Work Order ID 80137

Item Name: Crosstube Aft

DRAWING NO. D412-664-243	TITLE CROSSTUBE ASSEMBLY (412 HI AFT)	REV. E	DART AEROSPACE LTD ENGINEERING ORDER		D.E.O. NO. D412-664-243-E-1	SHEET NO. SHEET 1 OF 2	SCALE NTS
DRAWN	CHECKED	MFG. APPR.	APPROVED	DE APPR.			
DATE 11.03.31	DATE 11/03.31	DATE 11.03.31	DATE 11/03.31	DATE 11.03.31

DRAWING NO. D412-664-243	TITLE CROSSTUBE ASS'Y (412 HI AFT)	REV. E	DART AEROSPACE LTD ENGINEERING ORDER		D.E.O. NO. D412-664-243-E-2	SHEET NO. SHEET 1 OF 1	SCALE NTS
DRAWN P	CHECKED AS	MFG. APPR. E	APPROVED MP		DE APPR. H		
DATE 11.09.07	DATE 11.09.19	DATE 11.09.19	DATE 11.09.19		DATE 11.09.19

**D412-664-243
ASSEMBLY DETAIL**

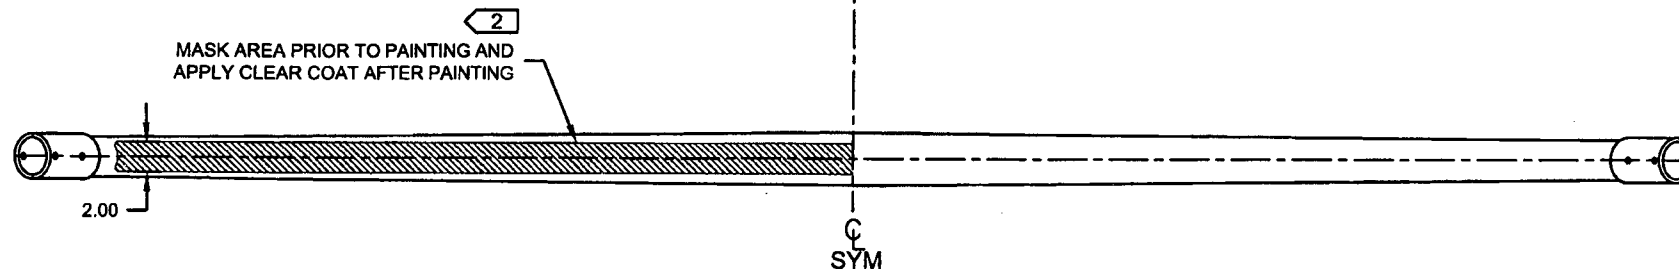
PURPOSE:

REMOVED ABRASION STRIP IN FAVOR OF A THIN LAYER OF PROSEAL 890.

IS:

D3189-1 CHAFING SHIELD (1, INSTALLED OVER PROSEAL 890)
MS21920-28 CLAMP, 2X
2 PL

WAS:

D2856-600-1009 ABRASION STRIP
D3189-1 CHAFING SHIELD (1, INSTALLED OVER ABRASION STRIP)
MS21920-28 CLAMP, 2X
2 PL

CRUSHING OF D912-664-243

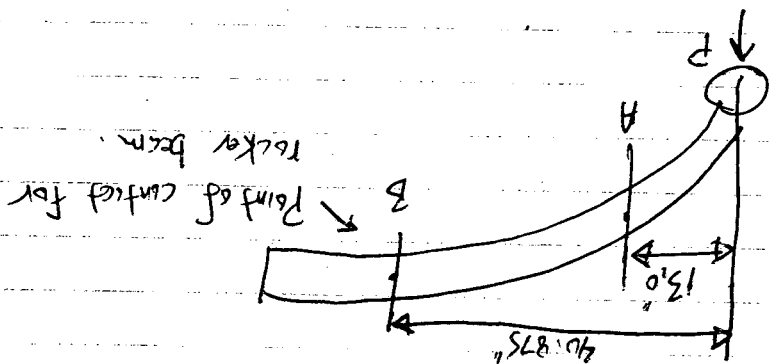
Acceptability of 8% CRUSHING AT END OF BEND

Point A: $\Delta D_1 = 2.961$, $\Delta D_2 = 2.522$

$CRUSHING = (2.961 - 2.522) / (2.961 + 2.522) = 8\%$

Point B: $\Delta D_1 = 3.307$, $I = 4.613 \text{ in}^4$

$$F = M_c / I = P \times 13 \times 2.961 / 2 \times 1.676 = 11.484 \times P$$

$$= P \times 40.875 \times 3.307 / 2 \times 4.613 = 14.651 \times P$$

$$M.S. = 14.651 / 11.484 - 1 = 0.27$$

∴ Tube will break at rocker beam contact before area of 8% crushing, 8% crushing in area at end of tube bend is acceptable
